Subject: Final Supplemental Response to NRC Request for Additional Information on the Hematite Decommissioning Plan and Related Revision to a Pending License Amendment Request (License No. SNM-00033, Docket No. 070-00036)

Final Supplemental Response to NRC Requests for Additional Information on Decommissioning Plan Chapter 1

Figure 11-2. Areas Requiring Special Effluent Limits

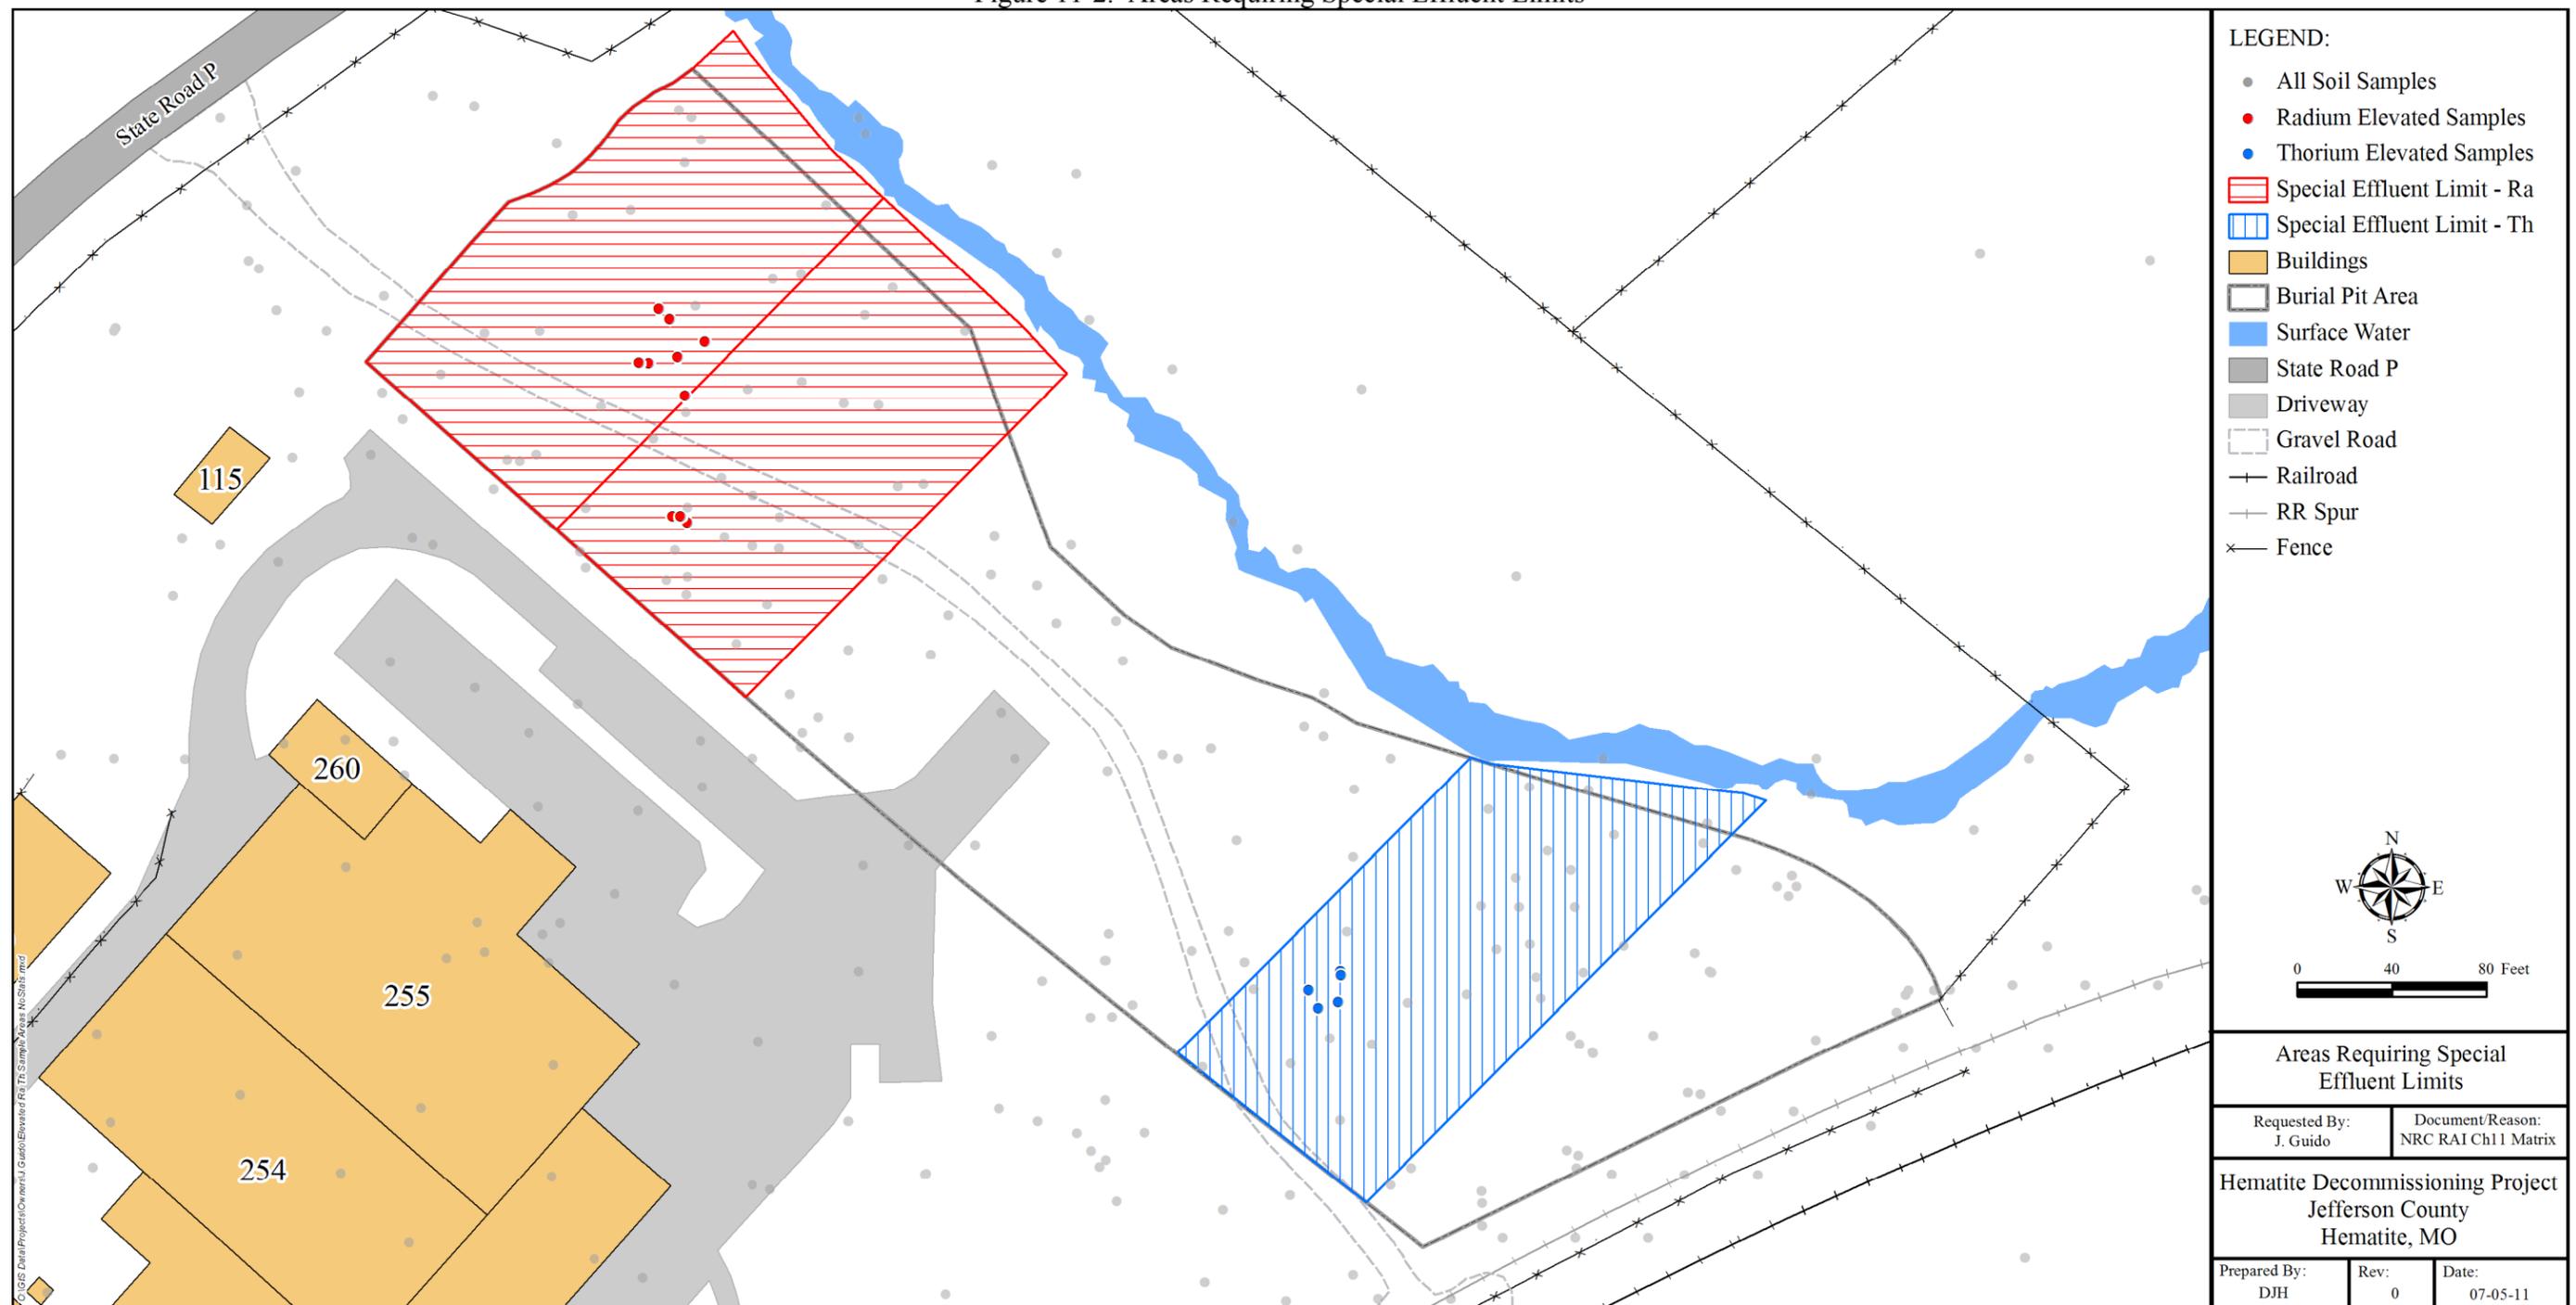
The NRC staff is agreeable to the usage of the Special Effluent Limit values, but it is still not clear whether soil outside the burial pit area will be treated and whether additional Th-232 special effluent limit areas exist. Figure 11-2 (provided in Attachment 4) only addresses the burial pit. While Th-232 impacted areas were not deemed appropriate for compliance surveys, Th-232 data indicate that there are additional elevated Th-232 samples outside of those currently designated in the updated Figure 11-2.

The Derived Effluent Limits for the Elevated Ra-226 Area and the Derived Effluent Limits for the Elevated Th-232 Area will only apply to effluents associated with soil/debris from the elevated Ra-226 and Th-232 areas, which are shown on Figure 11-2. The Derived Effluent Limits for the Balance of the Site will apply outside of these two areas. The boundaries of these areas are based on the conceptual survey units identified in DP Chapter 14.

A new DP Figure 11-2 will be added to DP Chapter 11; this figure is the last page in this attachment to the DP Chapter 11 matrix.
